Helitowcart - DESIGN CHANGE REQUEST-ORDER (ECR/ECO)	F20-01	Page 1 of 3
Reviewed & approved by:	/	2006 09 09

Nature of proposed change :	NEED INSTRUCTION TO REPAIR PADS TO ALLOC FIT WITH DART WEAR SHOE BOOTS (INSTR. FOR GRINDING)
Reason :	BOOTS KEEP FROM PROPERLY RESTING ON PAD.
Submitted By :	CCANDE BOOCHE, HELI CAN / DP
Date :	2015 02 06

Title:
Repair of BearPaw BP350 for Installation with Dart Wear Pads

EO Number:
HTC-EO-0709-003 Rev NC **Date issued:**
April 02, 2015

Figure 2 – Damages caused by Bolt Head Interference after first Installation

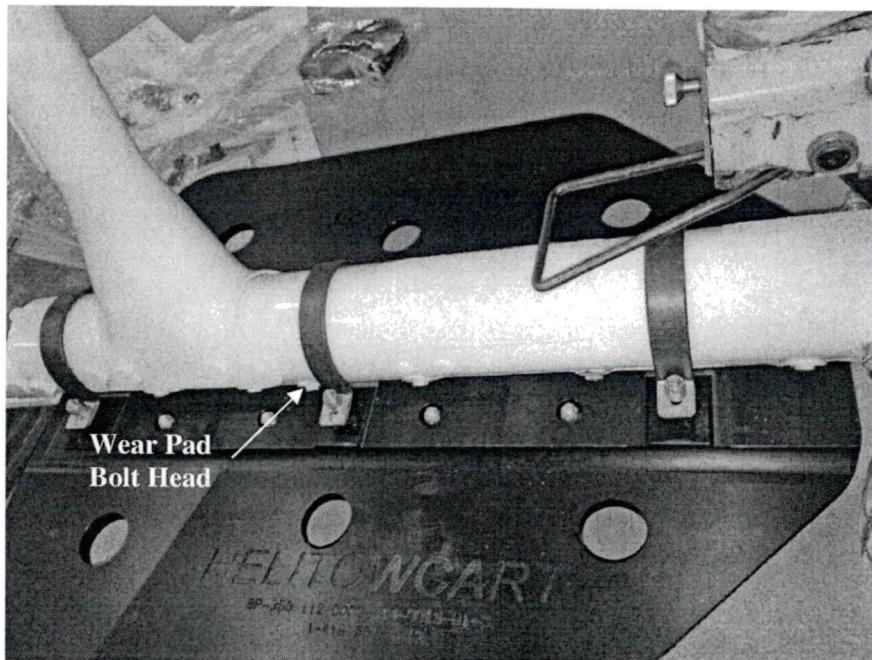
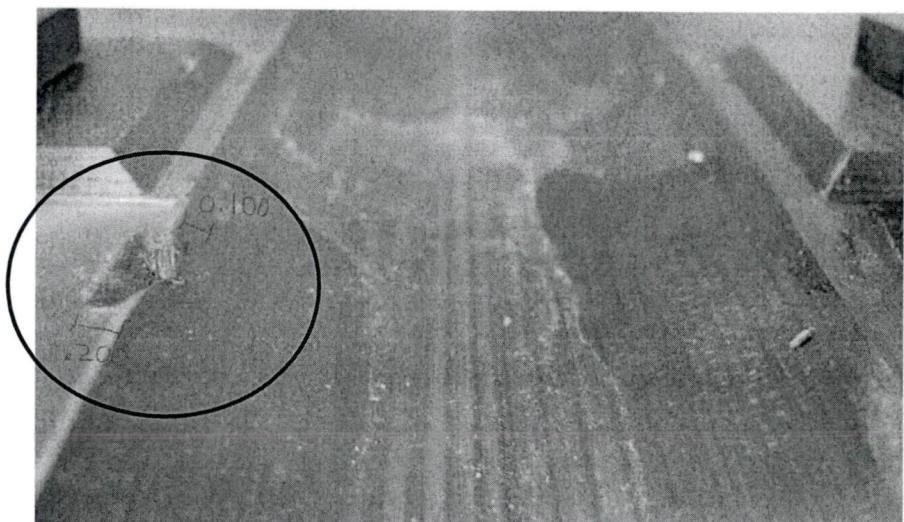
When BearPaw BP350 is installed on a skid equipped with Dart wear pads, interference occurs between bolt heads and BearPaw (Figure 1). This can damage the BearPaw, as shown on Figure 2. Damages on this figure were obtained directly after first installation, without performing any landing.

Figure 3 – Repair on BearPaw BP350

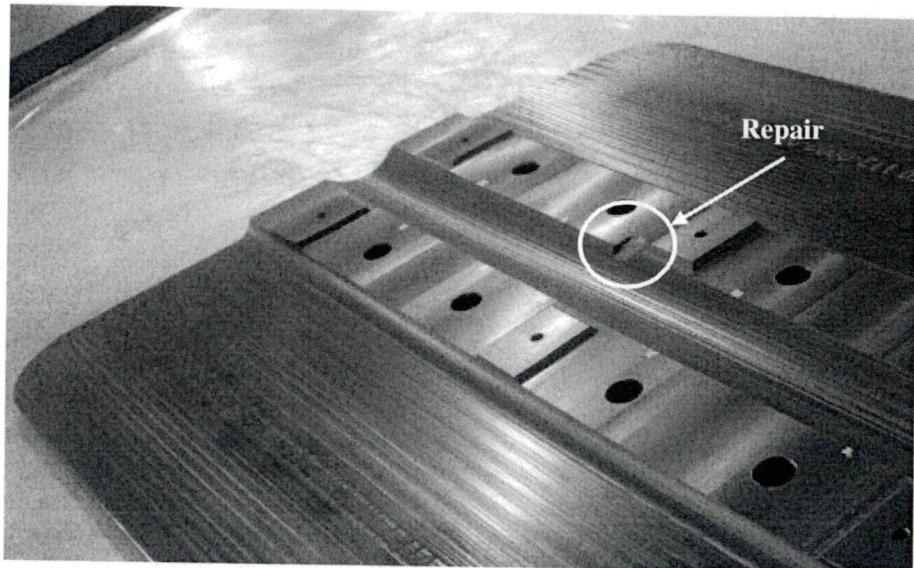
Repair consists in cutting small pockets in the BearPaw to clear the wear pad bolt heads (Figure 3).

Step#	Description	Product / Tool	Sign /Date
1.0	Initial Helicopter Preparation		
1.1	Prior to equipment installation, ensure that the helicopter is safe for maintenance.		
2.0	BearPaw Removal		
2.1	Mark on BearPaws the locations of wear pad bolts that interfere with BearPaw or could eventually damage it.		
2.2	Remove BearPaws from helicopter skid as per installation instructions.		
3.0	BearPaw Repair		
3.1	Remove all components from BearPaw pads.		
3.2	Repair BearPaw pads based on the following dimensions. 	Dremel End mill	
	NOTE Only repair BearPaws at locations where damage occurred, or where damage could eventually occur. Reduce above dimensions as required, except radius.

Figure 4 – Structural Substantiation – BearPaw BP350 Streamline Equivalent Stress

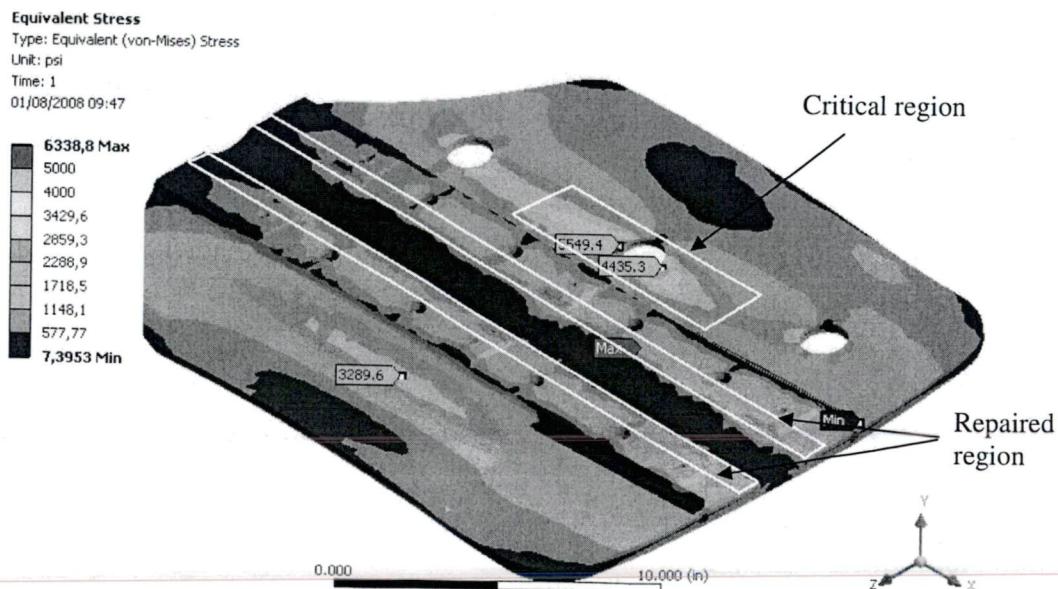
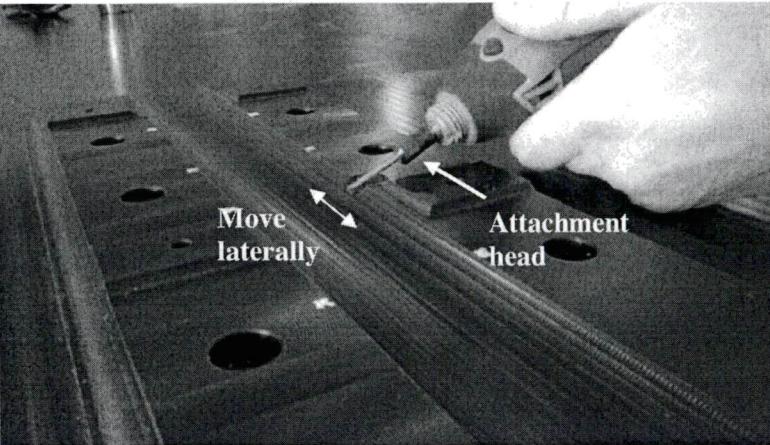
Structural substantiation of streamline BearPaw BP350 is performed in document HTC-MEM-0709-001 Rev A. Figure 4 is taken from this report and shows that equivalent stress is small in the region where the repair is performed since BearPaw thickness in this region is much larger than in the critical regions. Stress in this region for the repaired BearPaw will remain below stress in the critical region. Therefore, repair is structurally adequate.

Figure 2 – Damages caused by Bolt Head Interference after first Installation

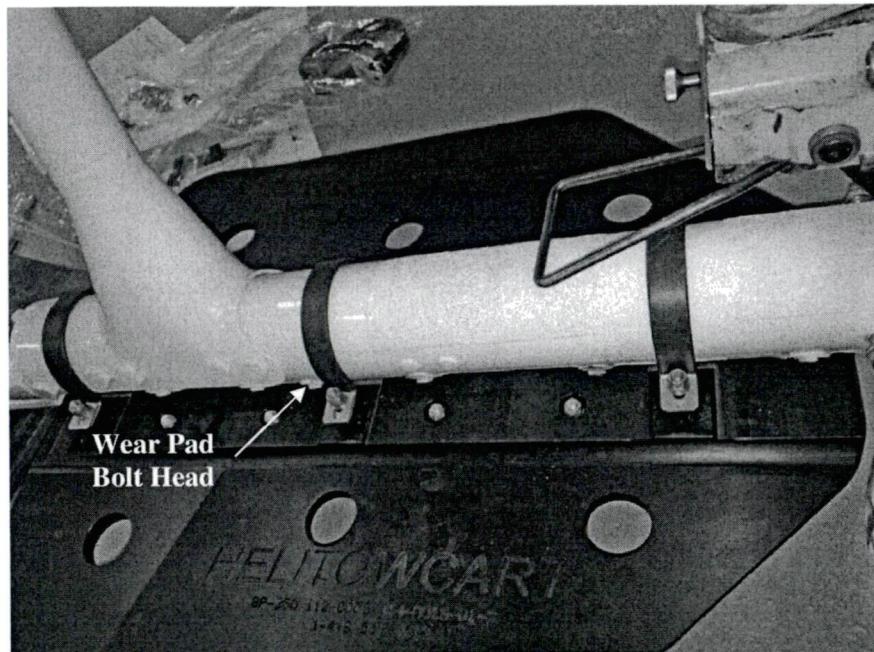
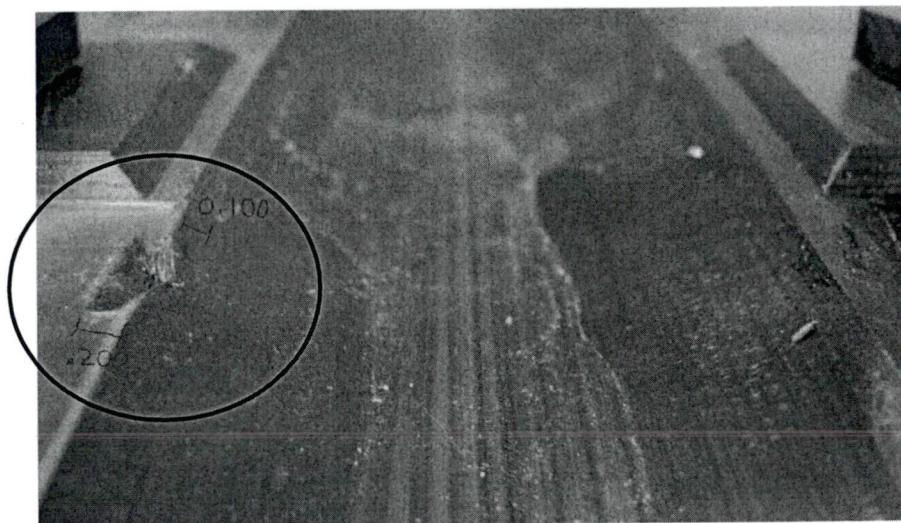
When BearPaw BP350 is installed on a skid equipped with Dart wear pads, interference occurs between bolt heads and BearPaw (Figure 1). This can damage the BearPaw, as shown on Figure 2. Damages on this figure were obtained directly after first installation, without performing any landing.

Figure 3 – Repair on BearPaw BP350

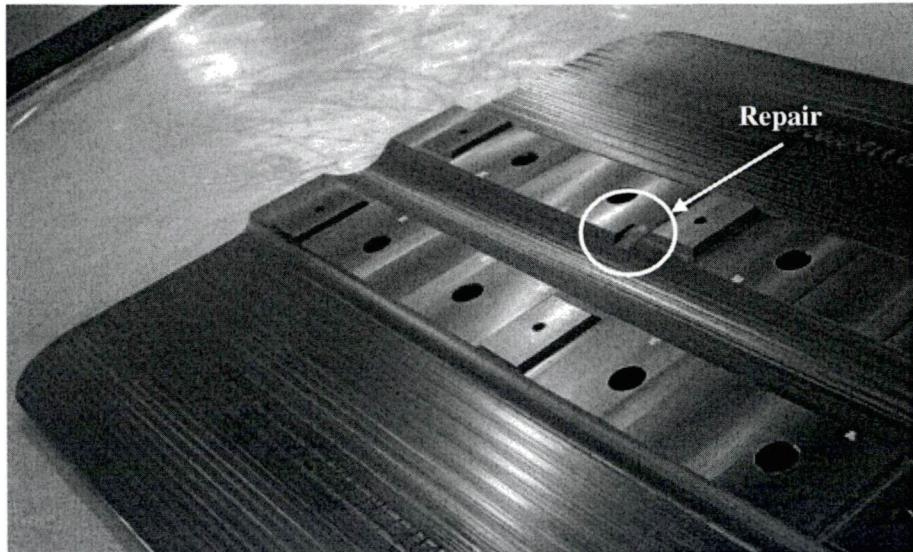
Repair consists in cutting small pockets in the BearPaw to clear the wear pad bolt heads (Figure 3).

Step#	Description	Product / Tool	Sign /Date
1.0	Initial Helicopter Preparation		
1.1	Prior to equipment installation, ensure that the helicopter is safe for maintenance.		
2.0	BearPaw Removal		
2.1	Mark on BearPaws the locations of wear pad bolts that interfere with BearPaw or could eventually damage it.		
2.2	Remove BearPaws from helicopter skid as per installation instructions.		
3.0	BearPaw Repair		
3.1	Remove all components from BearPaw pads.		
3.2	Repair BearPaw pads based on the following dimensions.  <div style="border: 1px solid black; padding: 5px; text-align: center;"> NOTE Only repair BearPaws at locations where damage occurred, or where damage could eventually occur. Reduce above dimensions as required, except radius. </div>	<i>Dremel</i> End mill

Figure 4 – Structural Substantiation – BearPaw BP350 Streamline Equivalent Stress

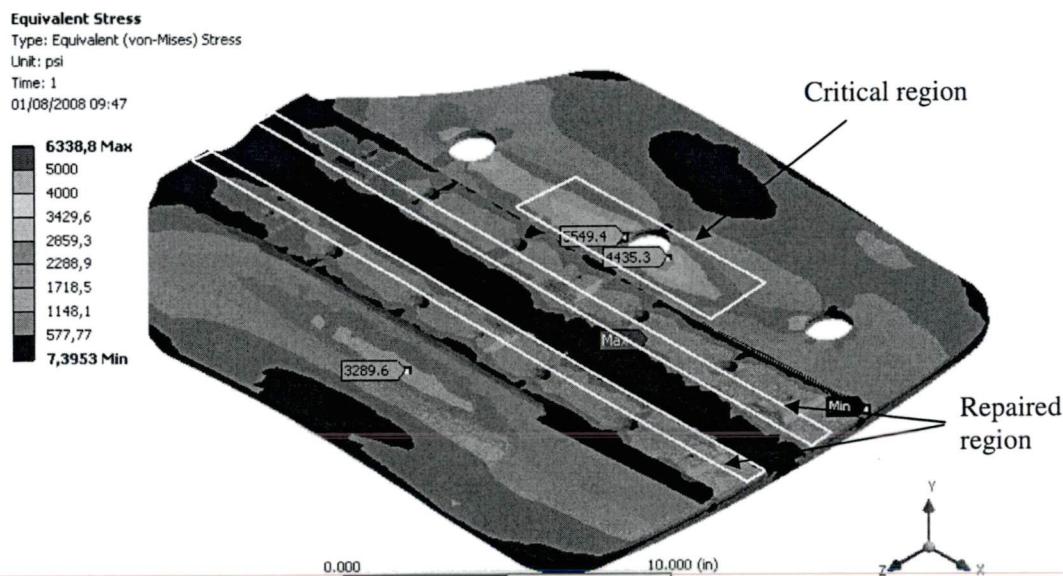
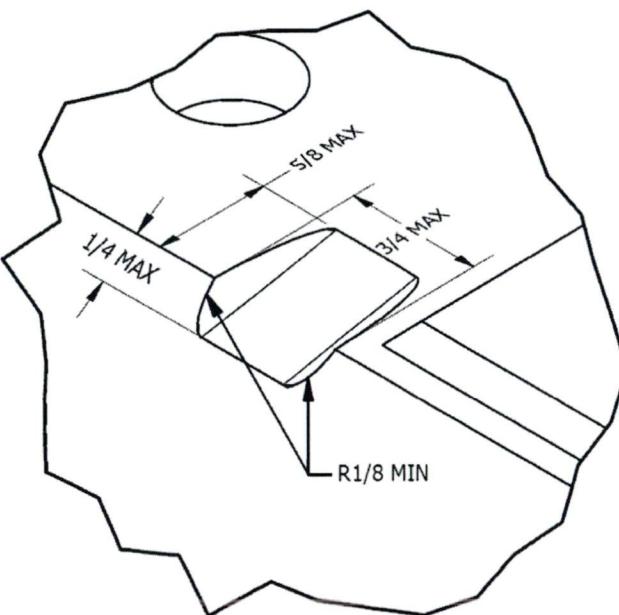
Structural substantiation of streamline BearPaw BP350 is performed in document HTC-MEM-0709-001 Rev A. Figure 4 is taken from this report and shows that equivalent stress is small in the region where the repair is performed since BearPaw thickness in this region is much larger than in the critical regions. Stress in this region for the repaired BearPaw will remain below stress in the critical region. Therefore, repair is structurally adequate.

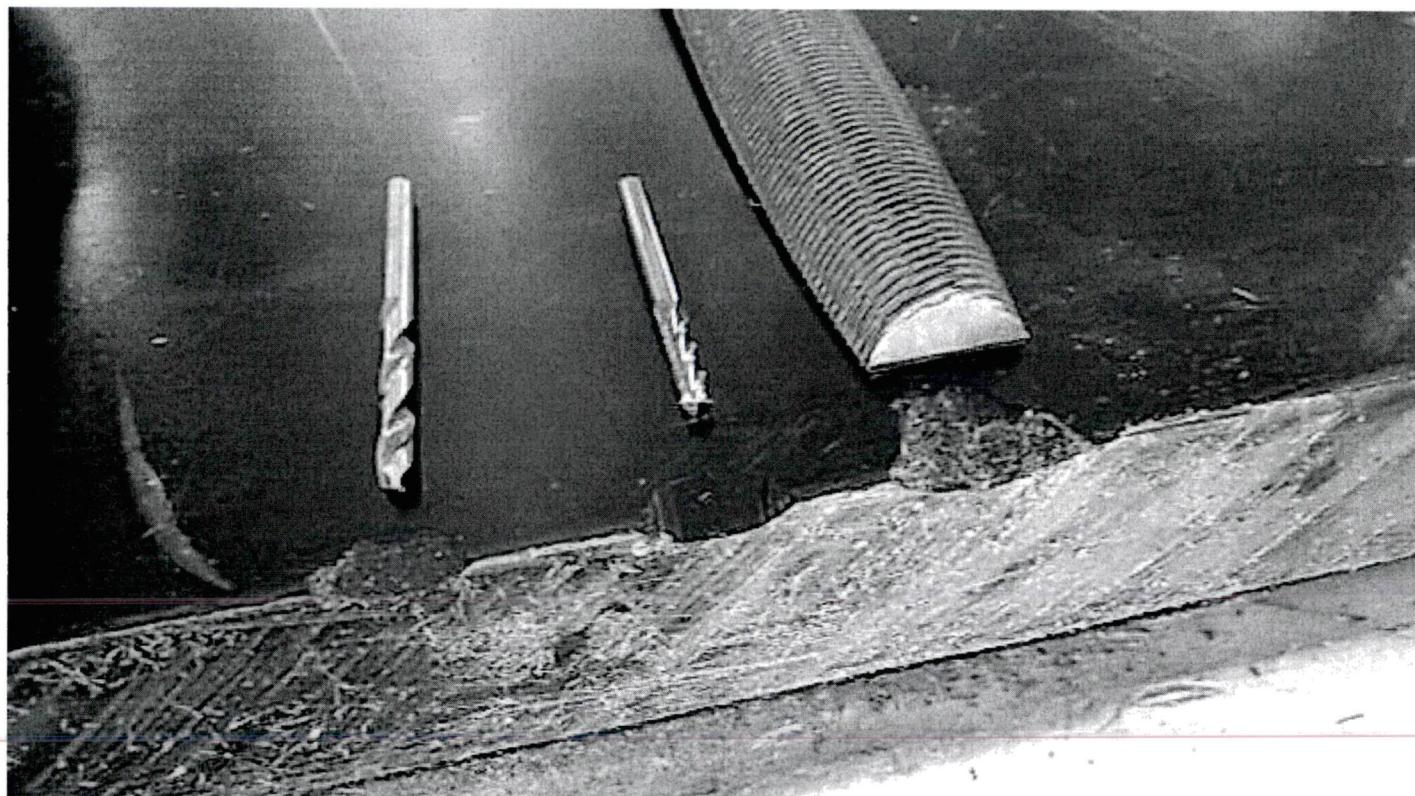
→ Je vais te retourner le pad. A noter, après avoir trouvé la technique de réparation recommandée dans le EO, nous avons fait d'autres tests sur le pad. La réparation finale sera donc plus esthétique que celle que tu pourras observer sur le pad et devrait ressembler à la réparation au centre de la figure ci-dessous.
Renaud

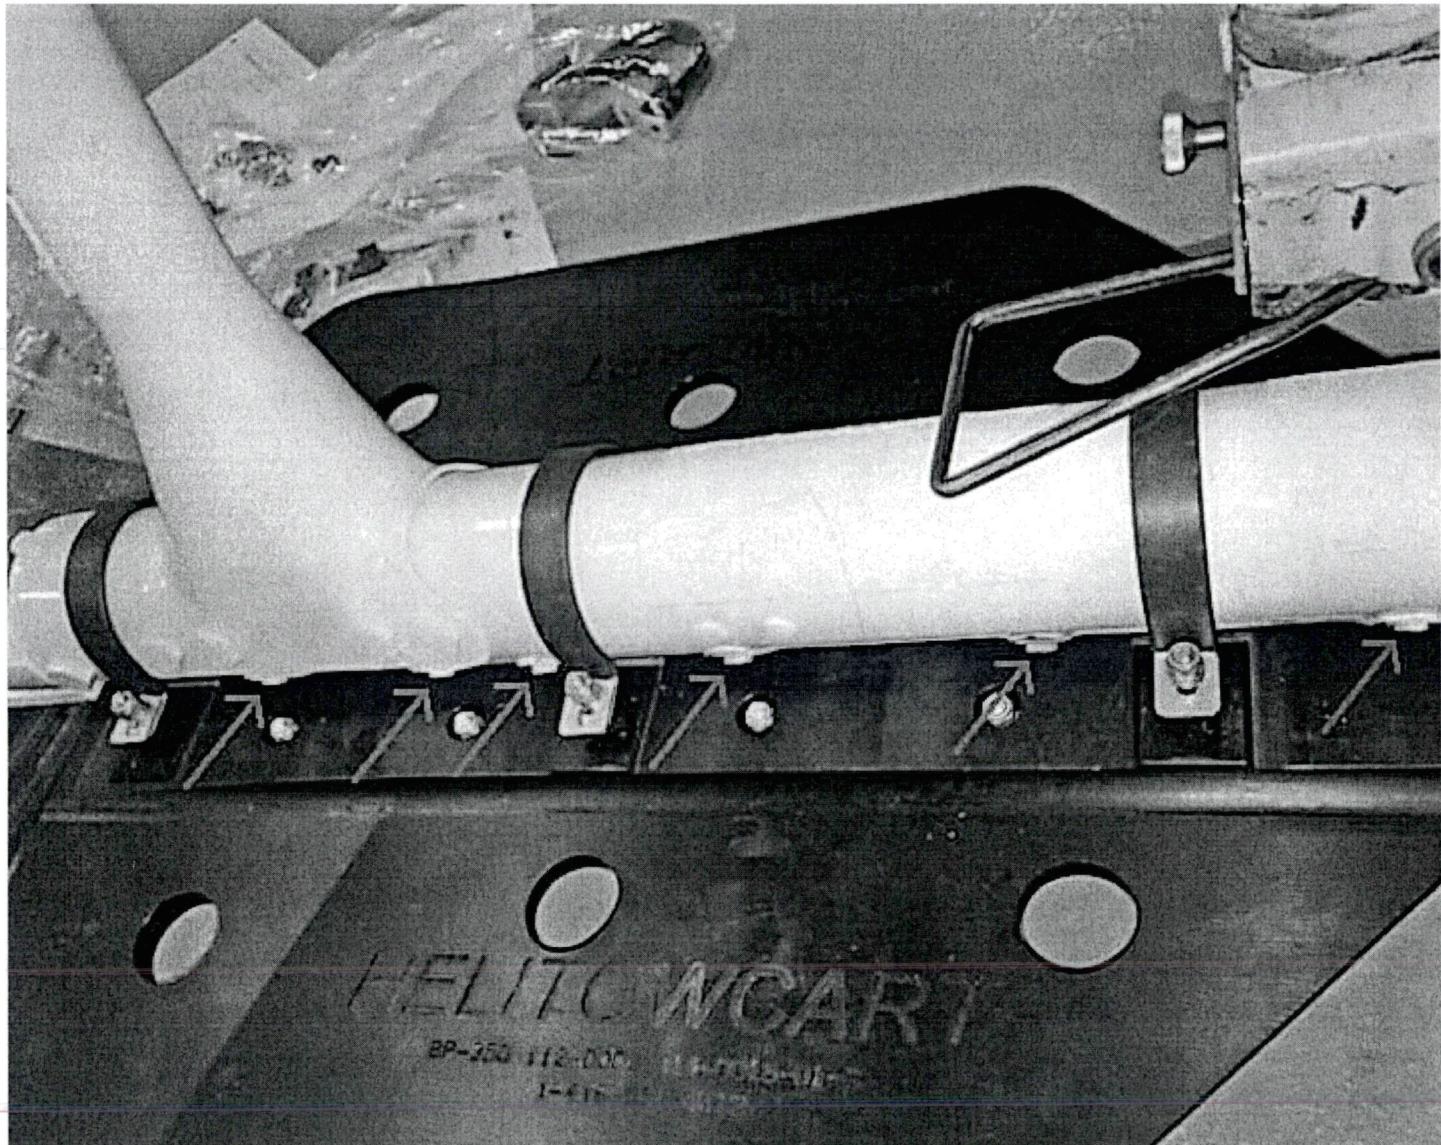
Est-ce que l'interférence se produit pour toutes les bolts des wear pads, tel qu'ilustré?
